PUR-1751
ADDENDUM NO. 5
INVITATION TO BID

HAGERSTOWN REGIONAL AIRPORT
EXPAND/REHABILITATE TERMINAL BUILDING EAST

DATE: Monday, June 23, 2025

SHEET No.: CV1.2 21 OF 102

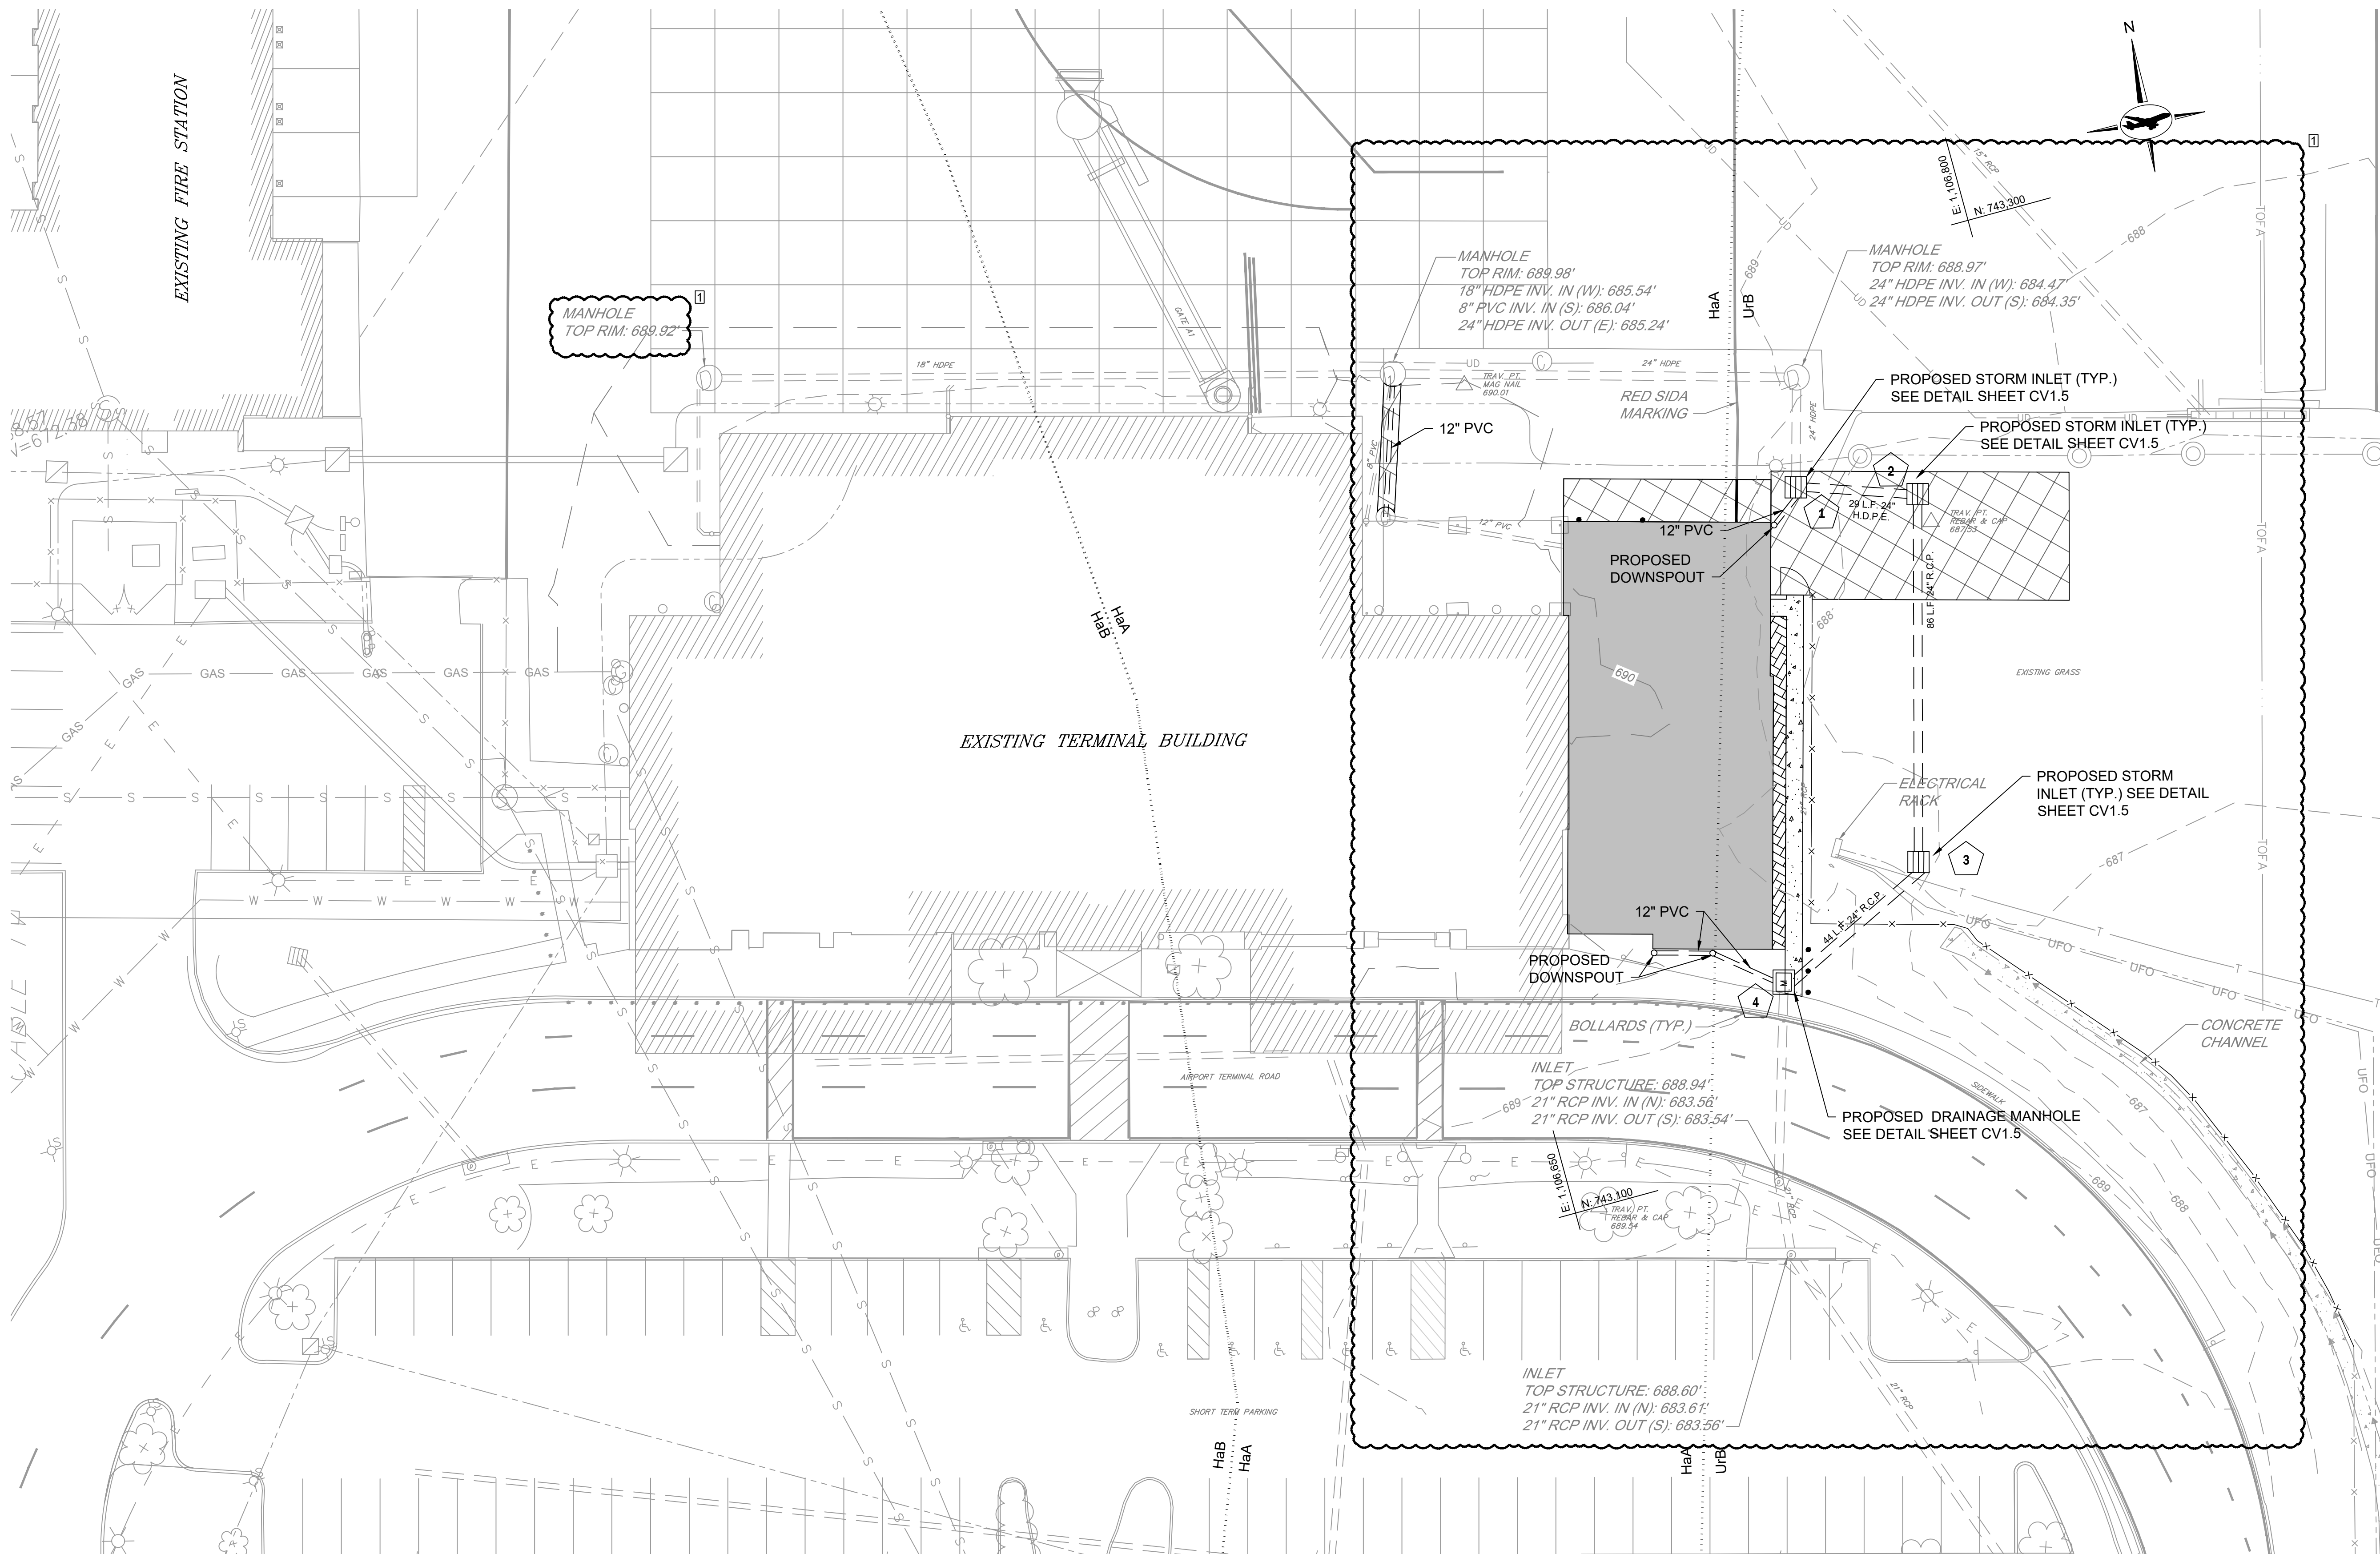
ITEM NO. 22: Inquiry: On the "C" set of the drawings they show river rock in the area between the sidewalk and proposed building, but on the "CV" set it is not shown or called out on the legend. Please clarify what the intent is in that area.

- ITEM NO. 45:** Sheet CV1.2 Final Conditions Plan:
Updated the plan sheet to show the river rock in the legend.
REVISE Replace sheet in entirety with attached revised sheet.

Response: River Rock shall be installed in the area between the sidewalk and proposed building. A REVISED CV1.2 Final Conditions Plan is included which updates the legend to include the river rock. (Attachment A)

6 PEDESTRIAN GATE
CV5.1 SCALE: NTS

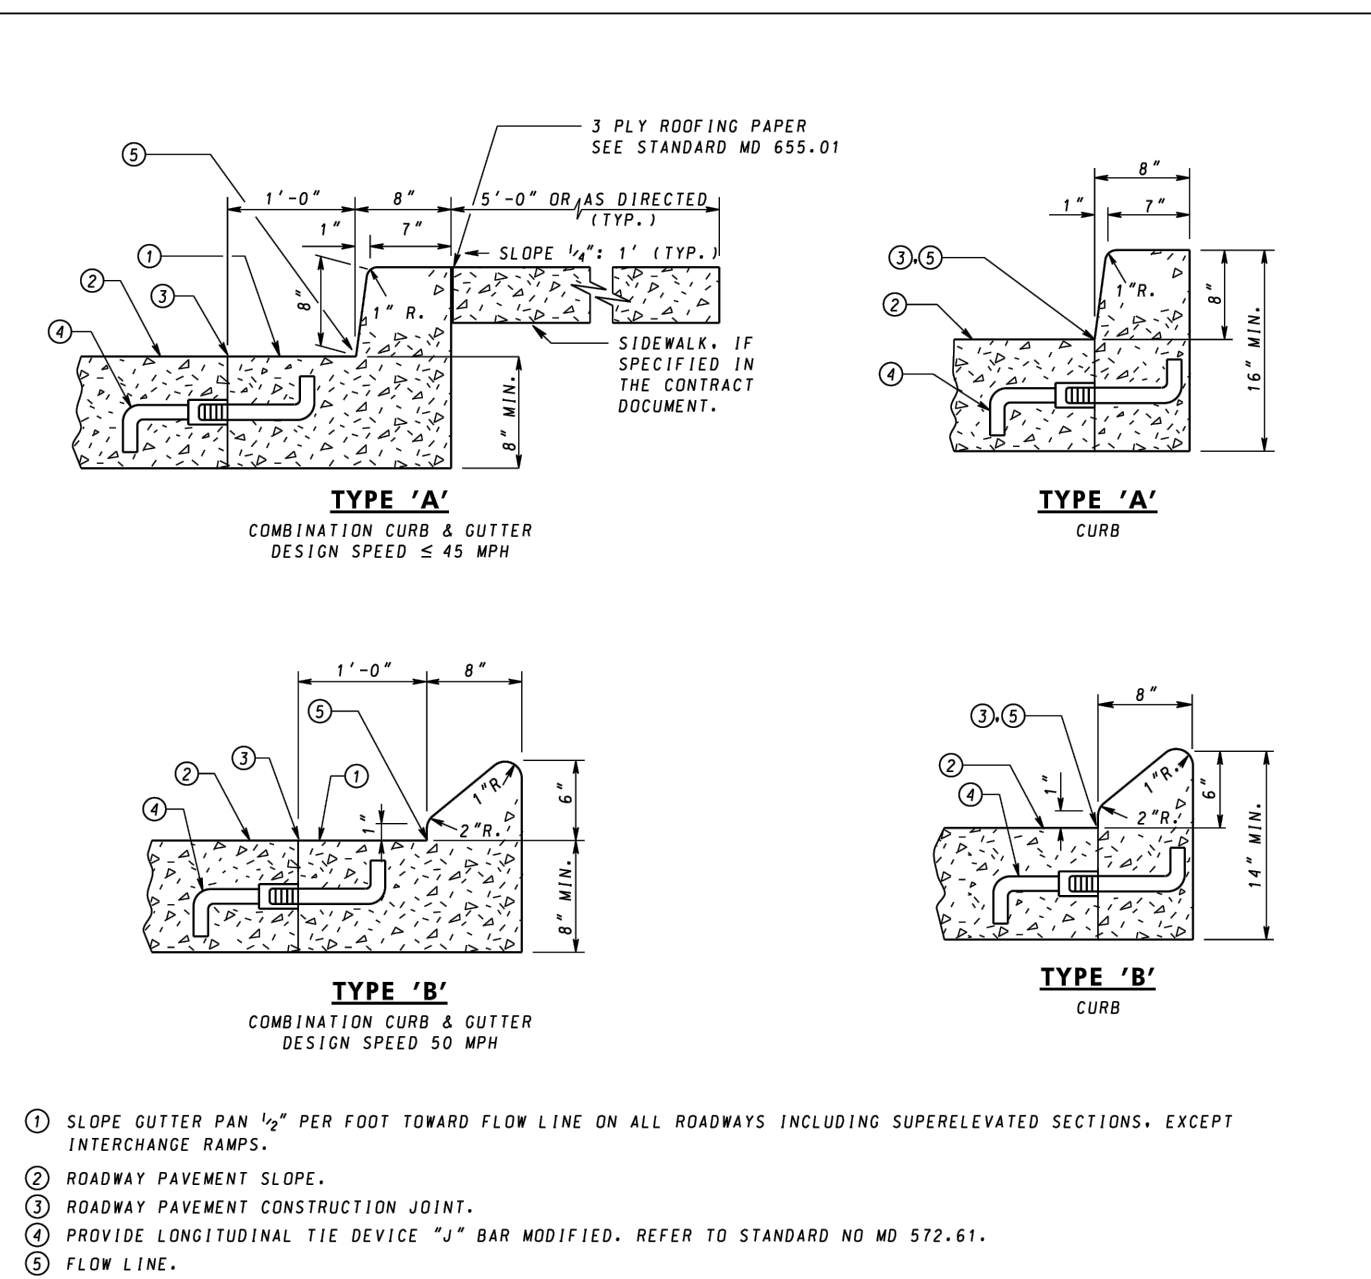
ITEM NO. 11: Inquiry: Ref.: Drawing C1.3 proposed main gate

1. Please provide a detail for the electrical and controls required at the proposed main.

Response: Part 1 of Item No. 11 herein: Refer to Pedestrian Gate Detail 6 on Sheet CV5.1. Provide a 120V circuit from the existing electrical rack using a 15-amp breaker in the existing panel on the rack. Extend power in 1.5" RGS conduit with 12 AWG THHN/THWN-2 conductors to a weather-rated electrical box housing a 12/24VDC regulated power supply for the electric gate lock system. From this electrical box, extend all control wiring to the electric gate lock system as Class 2 low-voltage wiring in weather-rated conduit, with proper grounding in accordance with NEC requirements. (Attachment A)
